**Resolution**  
**#96-08-08 A**

WHEREAS, Grant County has been petitioned to accept a portion of road in the Indian Hills Subdivision for inclusion into the Grant County Road System, for maintenance AND

RE: Anchor Ranch Subdivision  
Cotton Wood Road South of Schiff Trail

INDIAN HILLS, #3

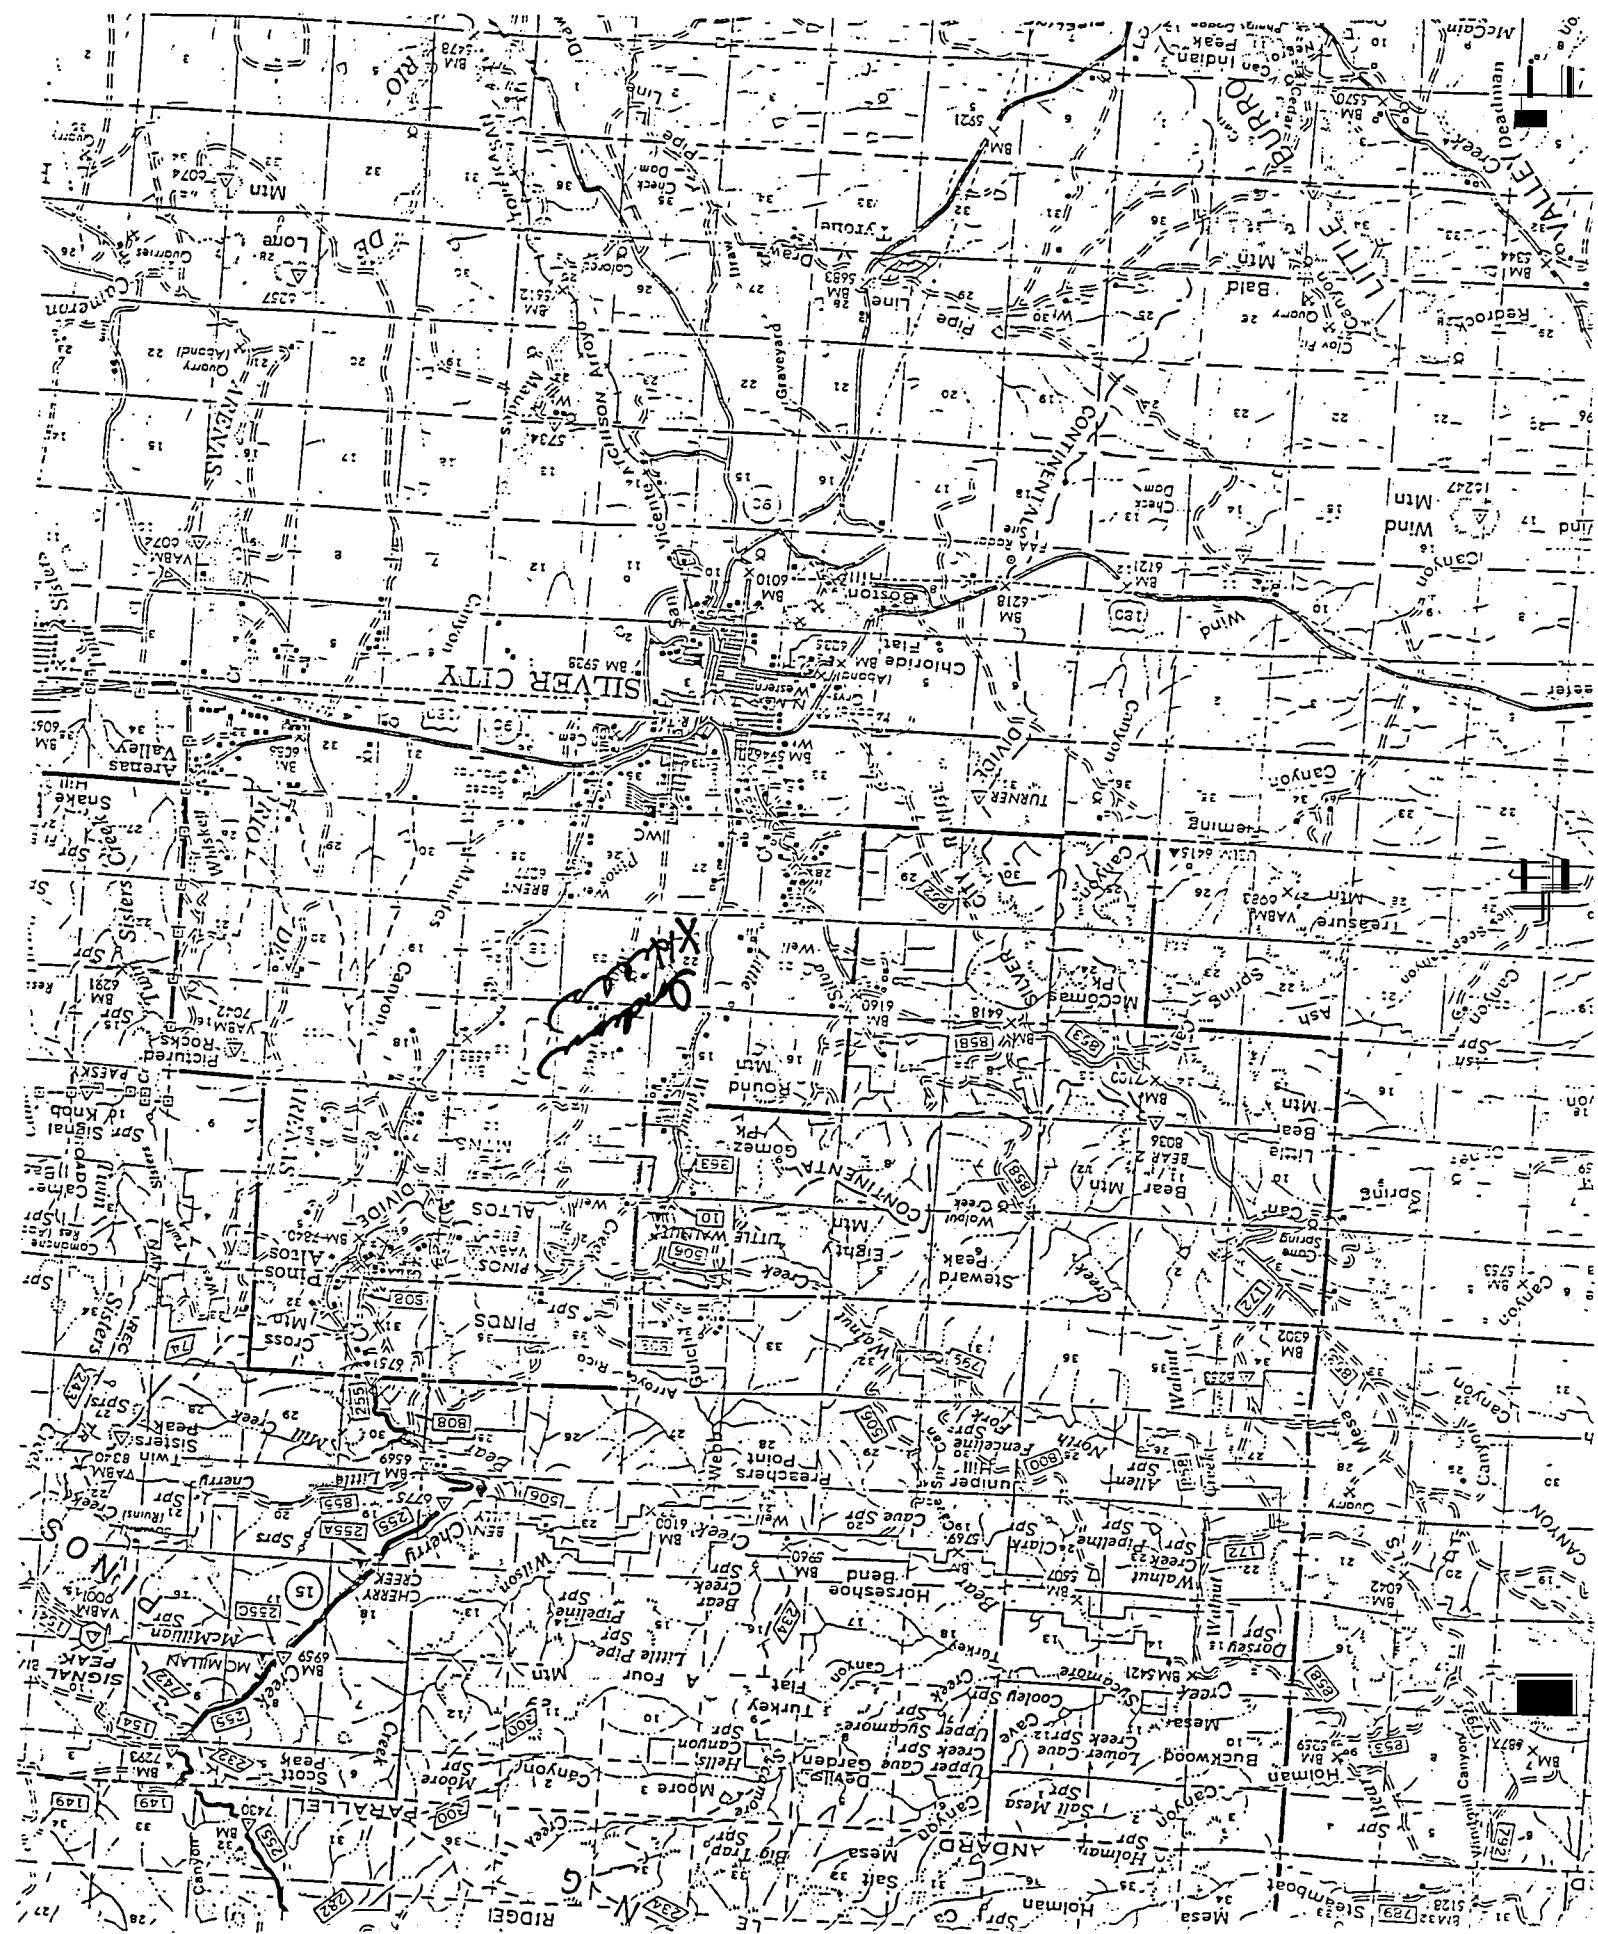
It is recommended that the county accept the remainder of Cottonwood, south of Schiff Trail, to where it connects to cottonwood off Cain Drive.

We also recommend the owner provide re-platting of subdivision to allow the county to properly maintain the roadway, ditches and culverts.

The properties on west side of roadway north of Arrowhead/Palo Verde intersection were known to have a problem. The property on the southeast corner of Cottonwood and Schiff Trail had a similar problem.

We agree with Mr. Sanchez that the concrete placed on outlet side of triple culverts should be repaired with asphalt.

This area needs signs, delineators (at culverts) and guard-rails at triple culverts (both sides) and double culverts (west side) and other locations to be determined by County Road Dept.
